IEEE P802.15
Wireless Personal Area Networks

Project	IEEE P802.15 Working Group for Wireless Personal Area Networks (WPANs)	
Title	TG3 D10 running comment resolutions	
Date Submitted	[8 July, 2002]	
Source	[James P. K. Gilb] [Apparent Technologies] [9921 Carmel Mountain Rd. #247, San Diego, CA 92129]	Voice: [858-538-3903] Fax: [858-538-3903] E-mail: [gilb@ieee.org]
Re:	[]	
Abstract	[This document is a record of comment resolutions for LB17.]	
Purpose	[To provide a record of the comment resolution for LB17.]	
Notice	This document has been prepared to assist the IEEE P802.15. It is offered as a basis for discussion and is not binding on the contributing individual(s) or organization(s). The material in this document is subject to change in form and content after further study. The contributor(s) reserve(s) the right to add, amend or withdraw material contained herein.	
Release	The contributor acknowledges and accepts that this contribution becomes the property of IEEE and may be made publicly available by P802.15.

1. Comment resolution in Schaumburg

Figure 5—Source DEV-2 Terminating its stream

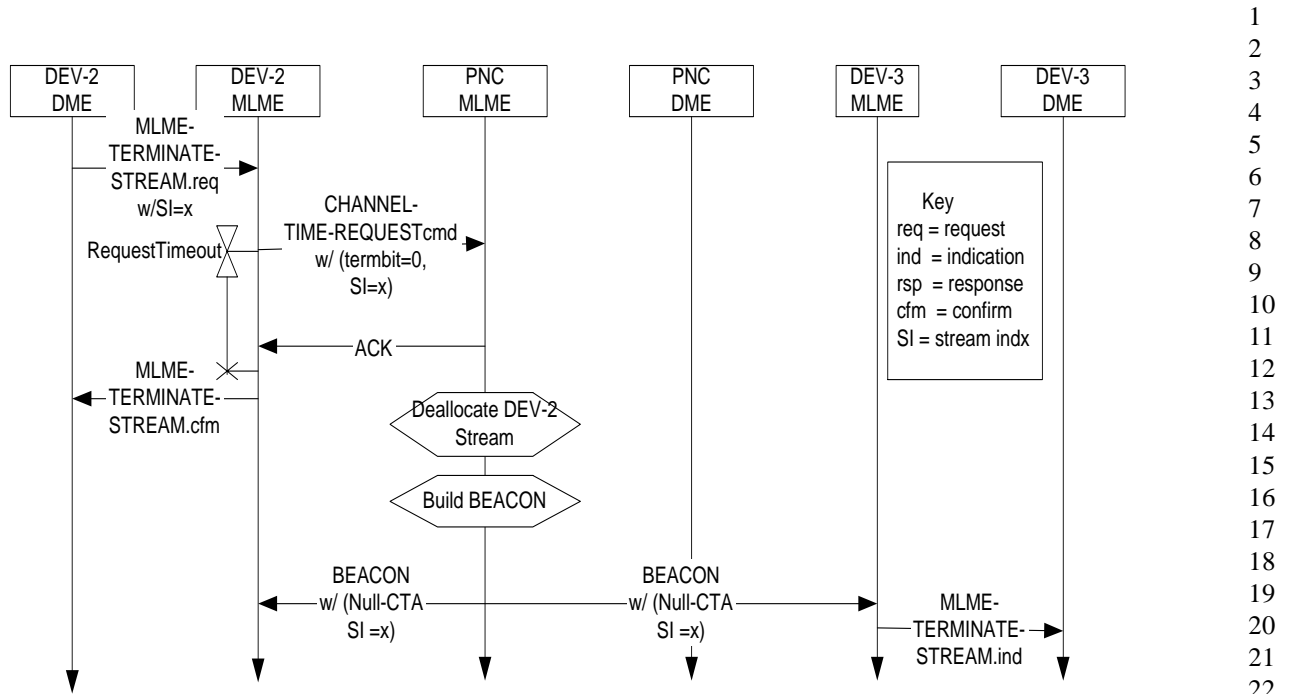
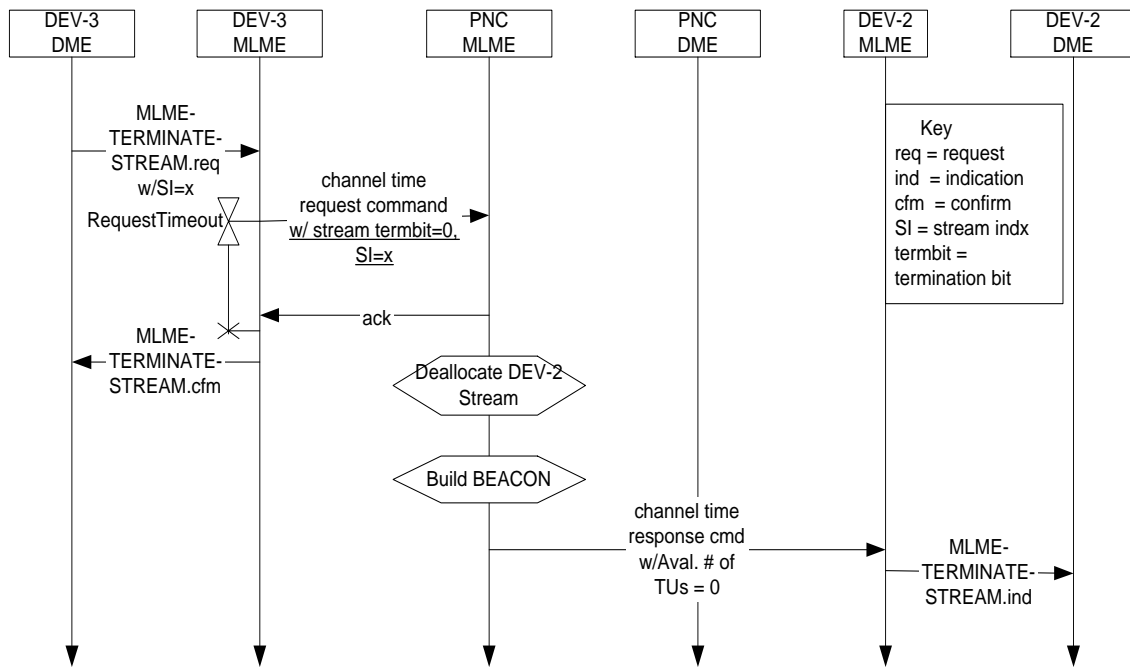
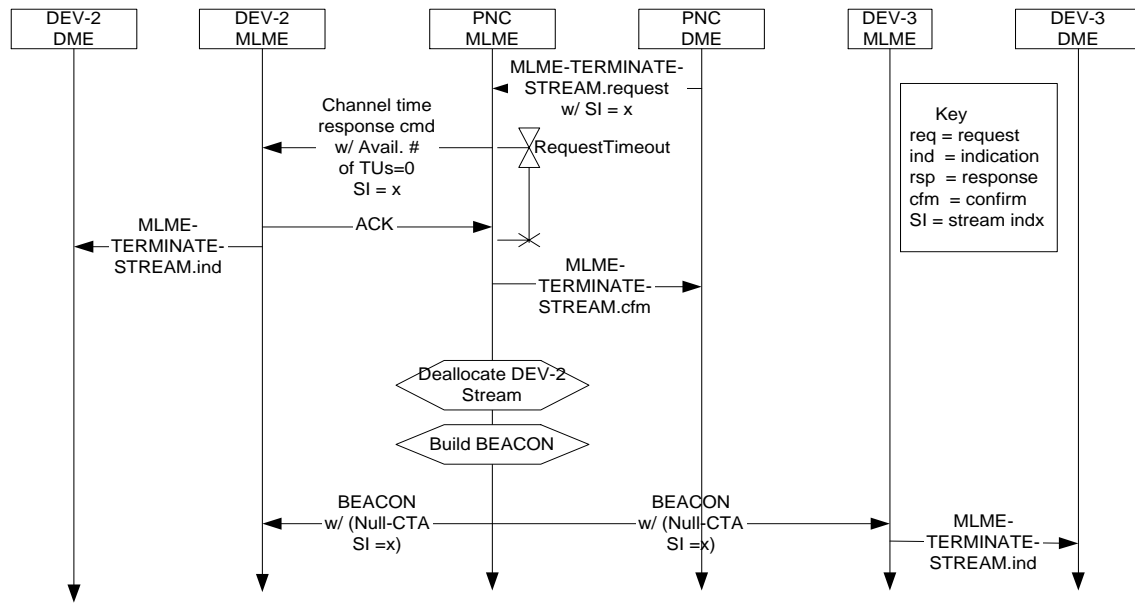
907 (Bain,TR) Grammatical errors and reference to figure 118 is incorrect and does not pertain to text in this section. Consequently, change the paragraph to the following: "In the case where the PNC wishes to terminate the stream, it shall notify the originating DEV and the target DEV via the next periodic beacon that the CTAs assigned to the indicated stream index are set to a null CTA value for aMinBeaconInfoRepeat duration." **Suggest reject** pending acceptance of CID 364

Resolution is to reject, "Figure 118 has been removed, a new termination procedure in 02/273r13 describes with correct MSCs the procedure."

The PNC, upon receiving a channel time request command from a DEV requesting stream termination, shall respond with an ACK. In the case where the stream originating DEV is requesting a stream termination, the PNC shall then notify the target DEV of the termination via a null CTA in the beacon for {xref aMinBeaconInfoRepeat} duration. For CTAs that were not allocated every beacon, e.g. subrate slots, the null CTAs shall be placed starting in the beacon where the next CTA would have occurred and in the following {xref aMinBeaconInfoRepeat}-1 beacons. A null CTA has the stream index, SrcID and DestID with zero values for the slot location and slot duration, {xref 7.4.8}. {xref Figure 5} illustrates the MSC for termination of a stream by a source DEV. In the case where the target DEV is requesting a stream termination, the PNC shall then notify the stream originating DEV of the termination via a channel time response command. {xref Figure 6} illustrates the MSC for termination of a stream by a target DEV.

In the case where the PNC decides to terminate a stream originating DEV's stream, the PNC shall notify the source DEV via a channel time response command and the target DEV via a null CTA in the beacon for aMinBeaconInfoRepeat duration. For CTAs that were not allocated every beacon, e.g. subrate slots, the null CTAs shall be placed starting in the beacon where the next CTA would have occurred and in the following {xref aMinBeaconInfoRepeat}-1 beacons. {xref Figure 7} illustrates the termination of a source DEV's stream by the PNC.

Figure 10—MSC for the initiating of a neighbor piconet.

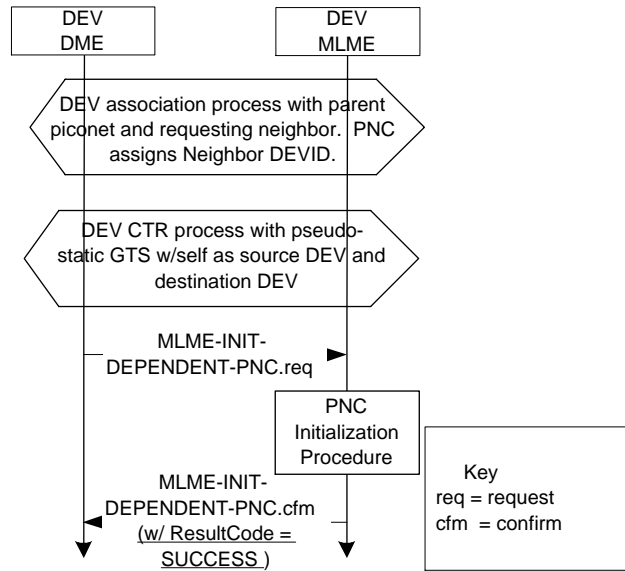
179 (Heberling, TR) - Figure 98 should be replaced with a proper MSC of the required protocol needed to establish a neighbor piconet. Replace figure 98 with a proper MSC. **Suggest accept** - An MSC for neighbor piconet initialization is included below. It needs twiddling to get the vertical lines to not show in the hex pro-

cess blocks. Also, although consistent with other similar diagrams, this MSC seems to need the first beacon of the neighbor PNC shown.

Accept in principle, “Accept suggested resolution but add a line at the bottom that shows the first beacon being sent. Also add after the sentence that says ‘The MSC for the initiation a neighbor piconet is illustrated in Figure 10.’ the following sentence, ‘The association and channel time request processes are defined in xref and xref, respectively.’”

Figure 11—MSC for the creating a child piconet.

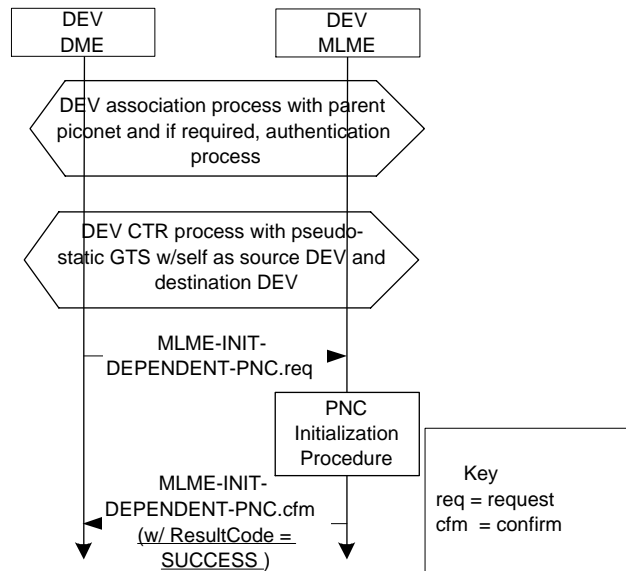
177 (Heberling, TR) - Figure 96 should be replaced with a proper MSC of the required protocol needed to establish a child piconet. Replace figure 96 with a proper MSC. **Suggest accept** 'An MSC for child piconet initialization is included below. It needs twiddling to get the vertical lines to not show in the hex process blocks. Also, although consistent with other similar diagrams, this MSC seems to need the first beacon of the child PNC shown.

Accept suggested resolution but add a line at the bottom that shows the first beacon being sent. Also add after the sentence that says 'The MSC for creating a child piconet is illustrated in Figure 11.' the following sentence, 'The association and channel time request processes are defined in xref and xref, respectively.'

Figure 12—MSC for a approved asynchronous channel time request

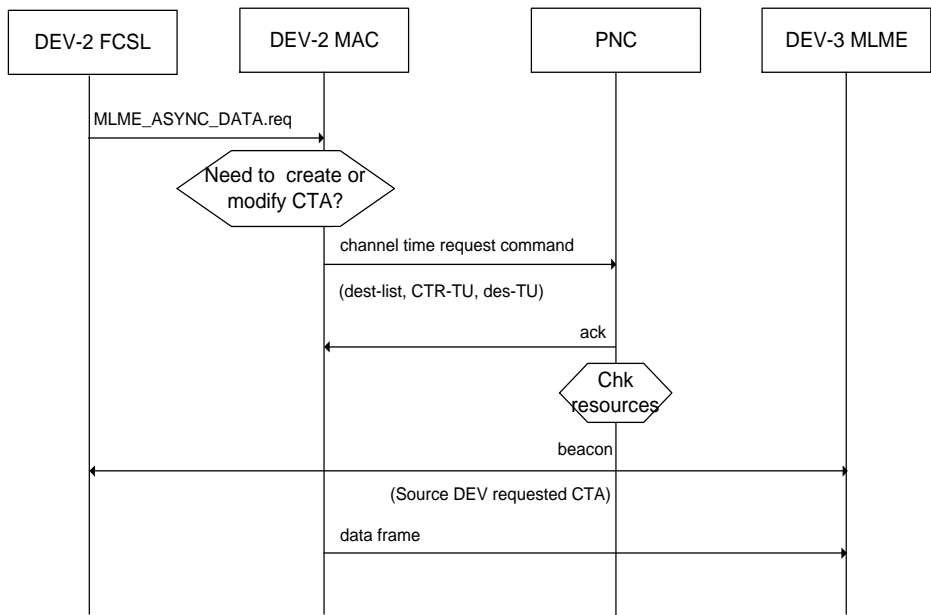
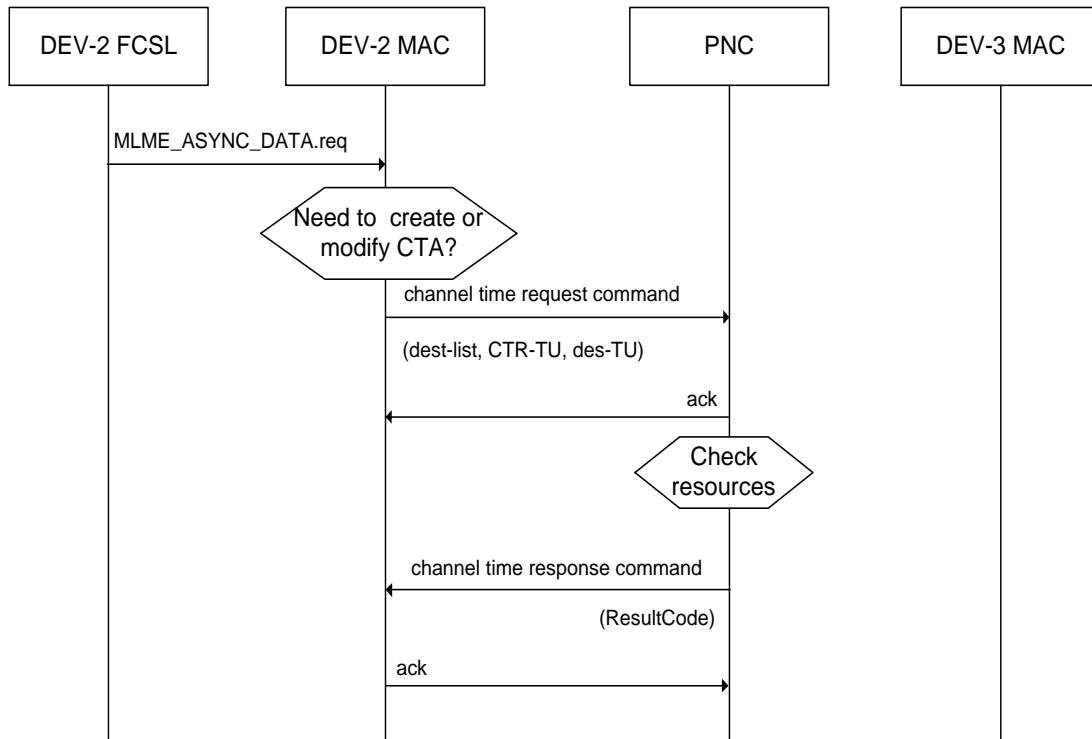
327 (Heberling, TR) Figure 119 is a flawed MSC of the Asynchronous channel time reservation process and data frame exchange. Consequently, delete the current MSC from this section of clause 8.5.2.1 and replace it with 02r0P802-15_TG3-Asynch-channel-time-allocation.eps. **Suggest accept.**

<Page 182, Figure 119> – MSC for reserving asynchronous data channel time. Discussed earlier, new MSC is below (needs work to match the other MSCs in the clause.):
